SEPTEMBER 16, 2022

ADDENDUM NO. 02 to the plans and specifications for the MACOMB COUNTY JAIL, VARIOUS PROJECTS PROPOSAL A, B AND C, MT. CLEMENS, MI, Architect's Project No. 221958, dated August 26, 2022

**PROPOSAL A-SANITARY REPLACEMENT**

**PROPOSAL B-BARRIER MESH/SCREEN**

Category: \_\_\_\_\_ Sheet: 6 - 3

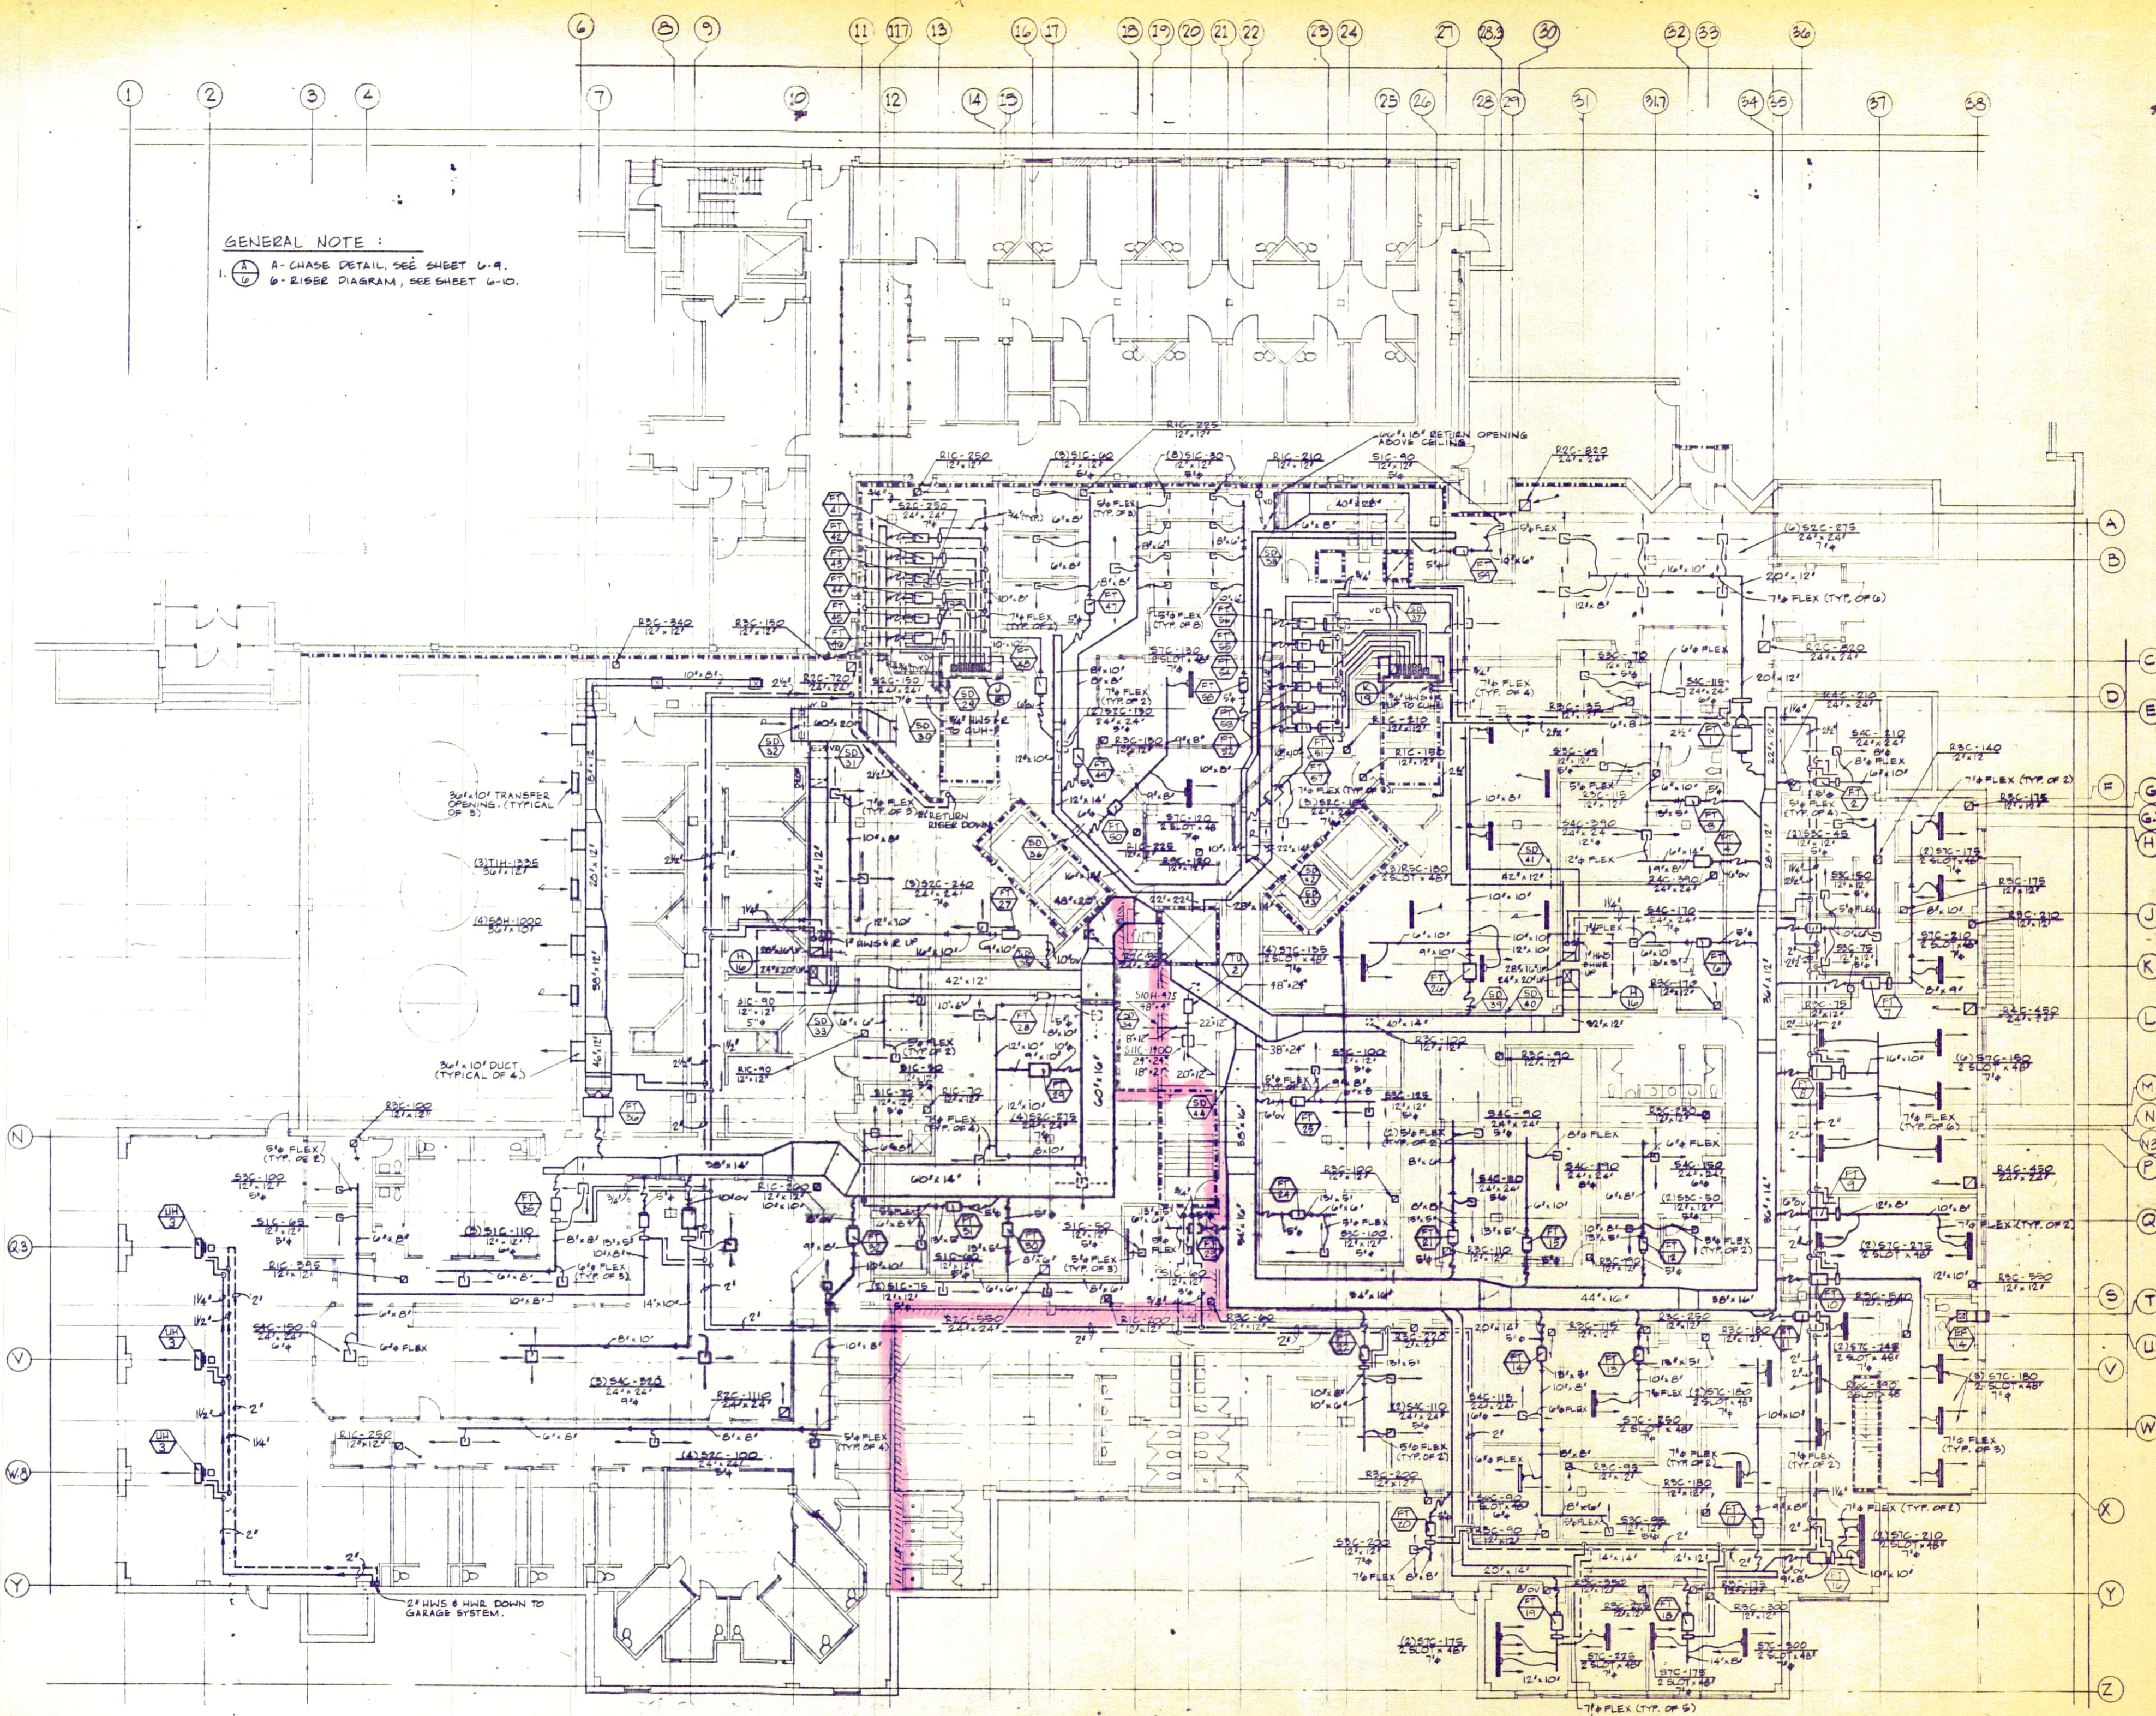
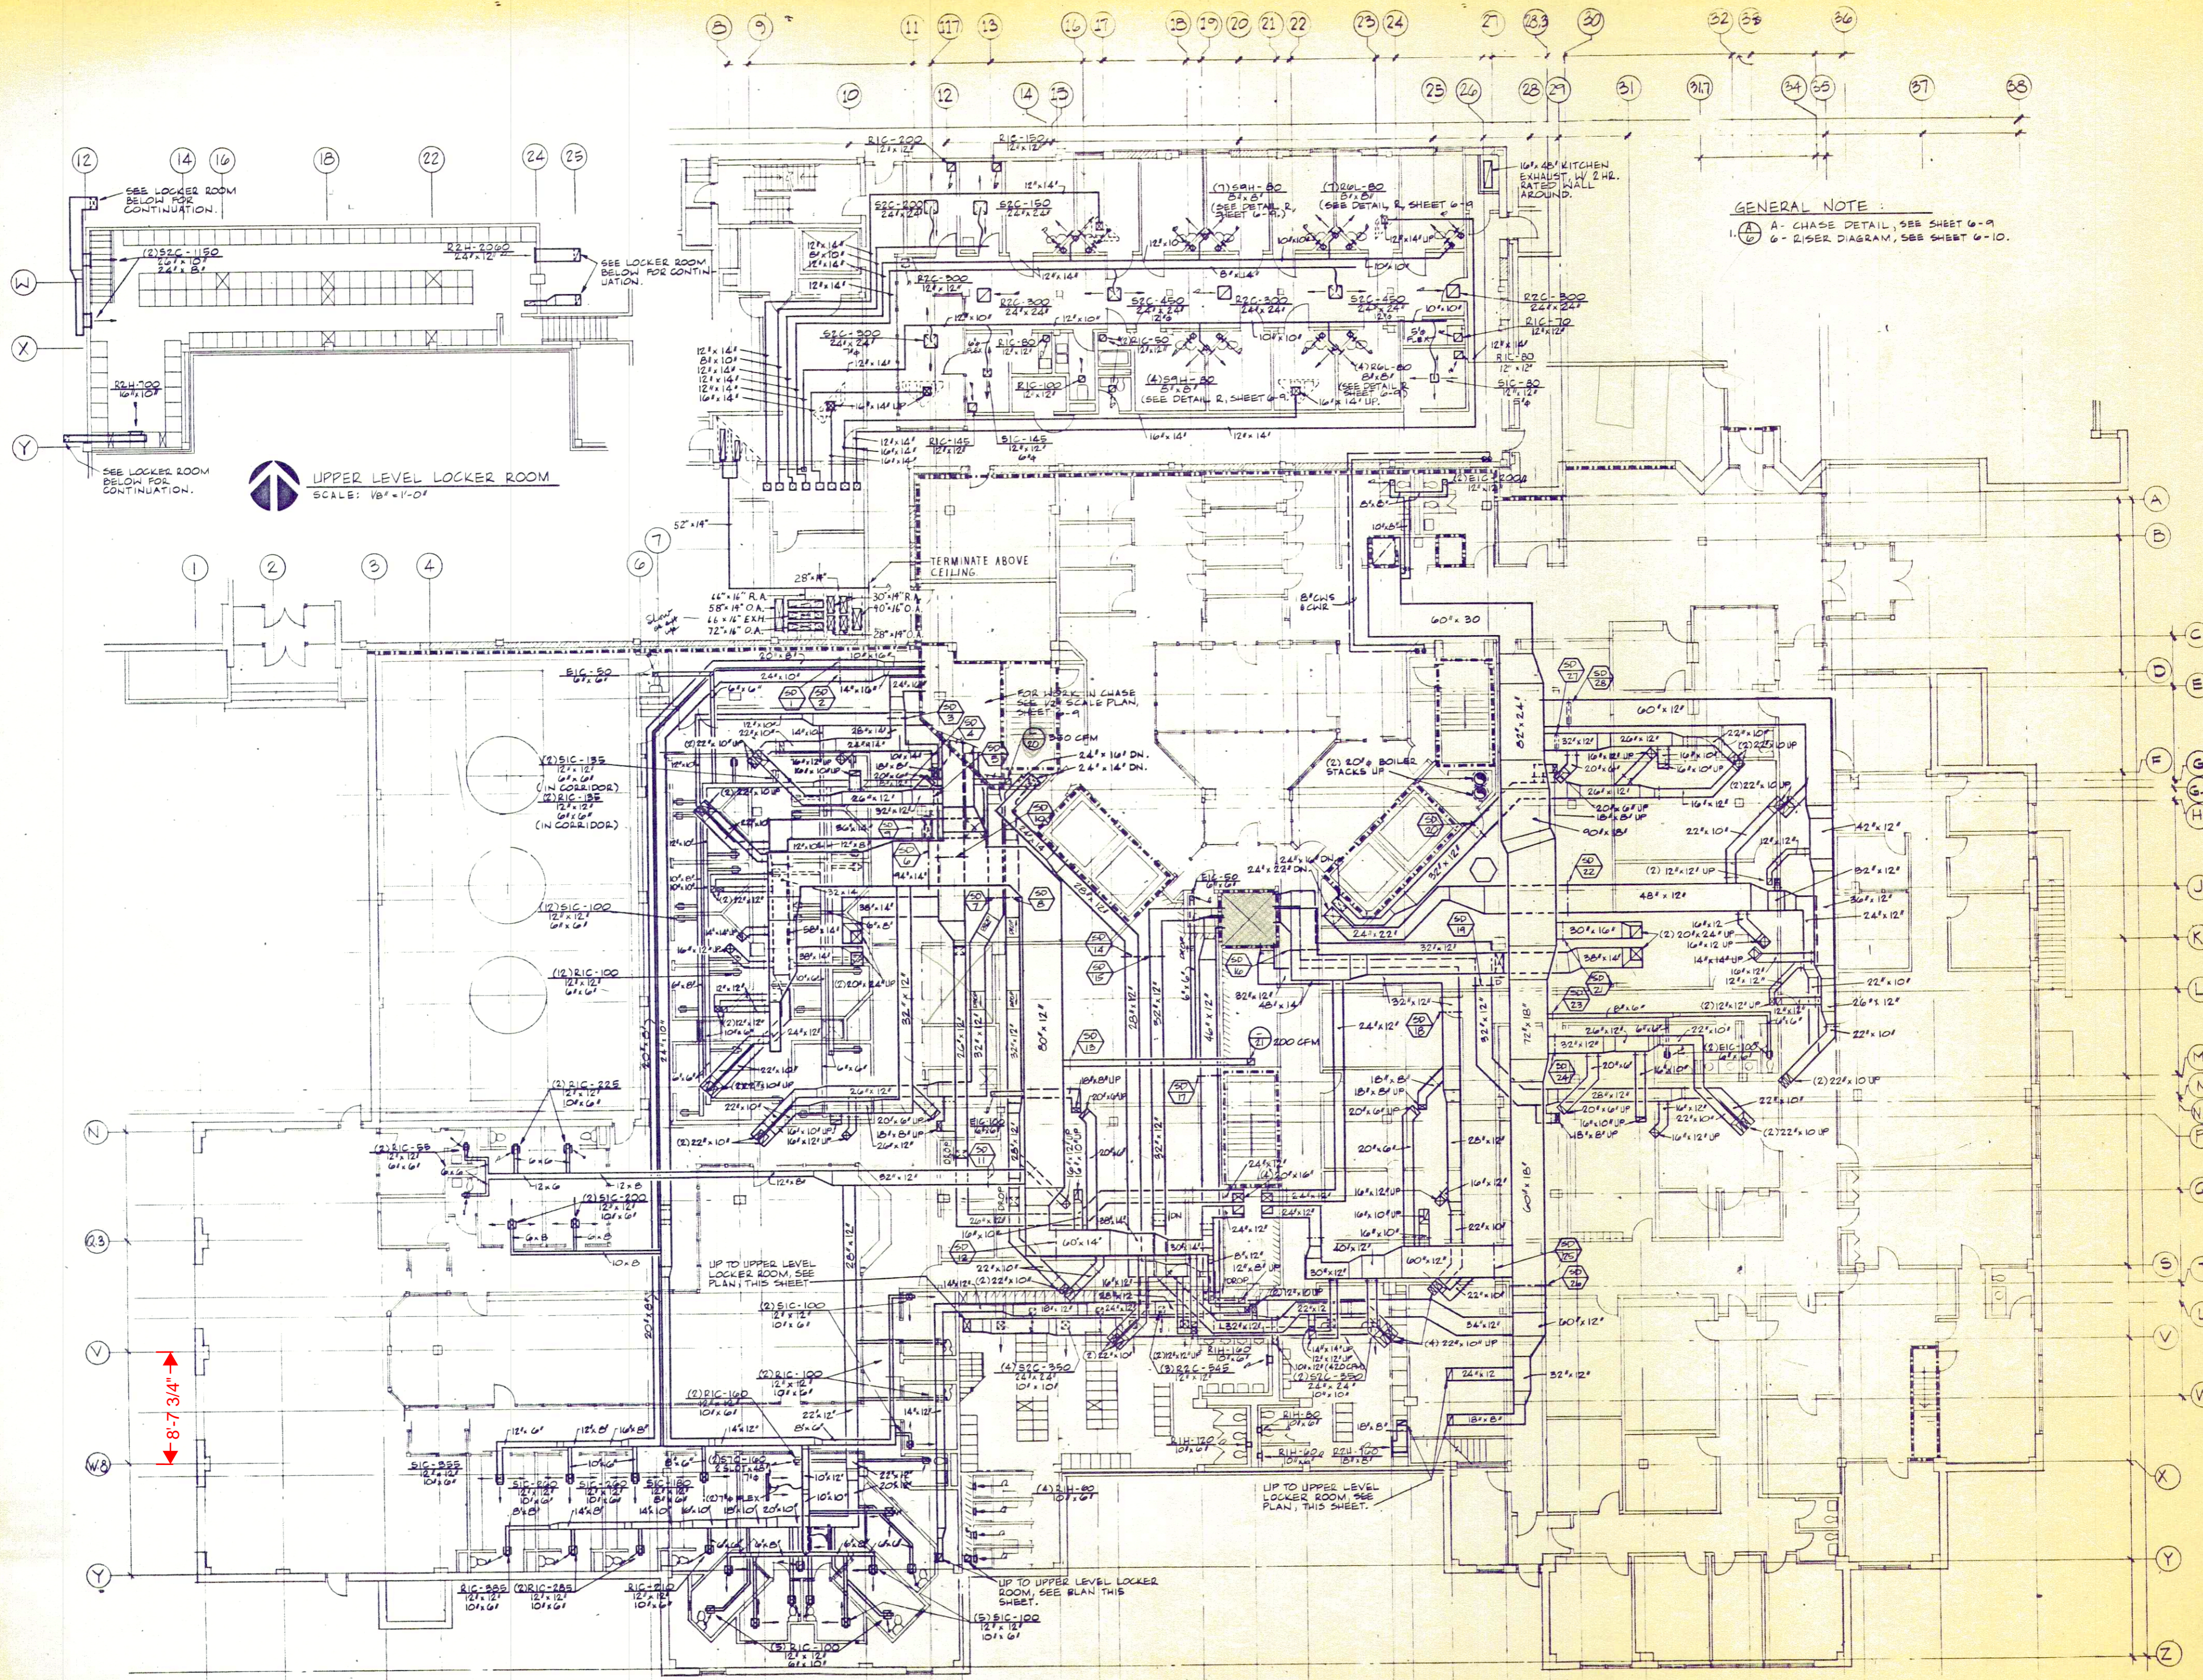
- ITEM NO. A4:** Refer to sheets 6-3, 6-4 and enlarged plan sketches SK6-3 and SK6-4.
1. Added sheets for reference of approximate location of existing ductwork in areas of sanitary line replacement. Contractor to remove and reinstall ductwork as they see required to access sanitary line.

Q1. It was discussed at the Project Pre Bid that the drawings indicate what ductwork is required to be removed to allow for the removal and replacement of the existing sanitary line. After reviewing the drawings, the drawings do not indicate what ductwork is required to be removed and reinstalled for the replacement of the existing sanitary line. An allowance would be the proper way to manage this issue.

**A1. The attached existing drawings show the ductwork to be removed/replaced for the replacement of the existing sanitary line. There will be no allowances for this issue.**
